United States Patent and Trademark Office

APPLICATION NO. FILING DATE		LING DATE	FIRST NAMED INVENTOR	ATTORNEY DOCKET NO.	CONFIRMATION NO.
10/090,741	(03/06/2002	Jun Miyokawa	219404US8	5255
22850	7590	10/28/2003	EXAMINER		
•		MCCLELLAND,	WONG, ERIC K		
1940 DUKE ALEXANDI		22314	ART UNIT	PAPER NUMBER	
	•			2874

DETAILED ACTION

Reproduced from Reference Katayama et al.

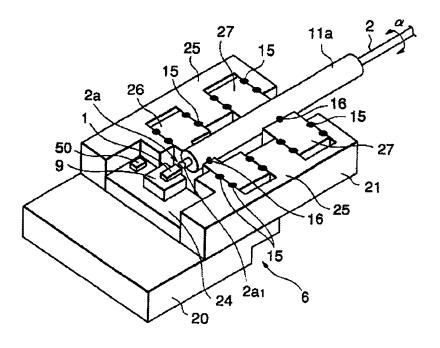
As to claims 1, 2, 3, 5, 6, 8, 9, 10, 11, and 20, Katayama discloses in figure 5A, a semiconductor laser module comprising:

A semiconductor laser configured to emit light (1);

An optical fiber having a tip end portion opposing said semiconductor laser and formed in a lens shaped configuration so as to optically couple light emitted from said laser (2a);

- An optical fiber supporting member configured to support said optical fiber (11a);
- A first fixing block and a second fixing block portion positioned on opposite sides
 of a supporting member (26),

- A first bridge portion (where 16 welds),
- A second bridge portion (opposite 16), and
- As to claim 4, a group of fixing members (26, 27) are present which hold a fiber ferrule in place,

- As to claim 7, the first and second fixing members are non-integral as they need to be welded,
- As to claim 12, the base includes a semiconductor laser-mounting member (9) and a fixing-member mounting member provided on the semiconductor laser mounting member,

- As to claim 13, said semiconductor-laser mounting member and base are integrally formed as a single member (1, 9 and 24),
- As to claim 14, the first fixing-member mounting member has a first recessed
 portion corresponding to a first fixing block portion and a second recessed portion
 corresponding to a second fixing block so as to fix the first and second by
 respective recessed portions (25),

As to claim 15, the fixing members have a joining member in the same plane (welds are in the same plane),

- As to claim 16, the fixing members have an upper surface arranged at a substantially same height as a center of propagation oath of light emitted from said laser,
- As to claims 17 and 18, the material of the fixing member is one of Fe-Ni (Prior Art, Paragraph 8 and 9) and has the same thermal expansion coefficients,
- As to claim 19, joining portions are laser-welded (15, 16 and paragraph 86), But fails to explicitly disclose
- A supporting member-fitting portion having a channel into which said optical fiber supporting member is placed and supported and
- A fixing member being fixed with alignment in the axes as claimed in claims 21 and 22,
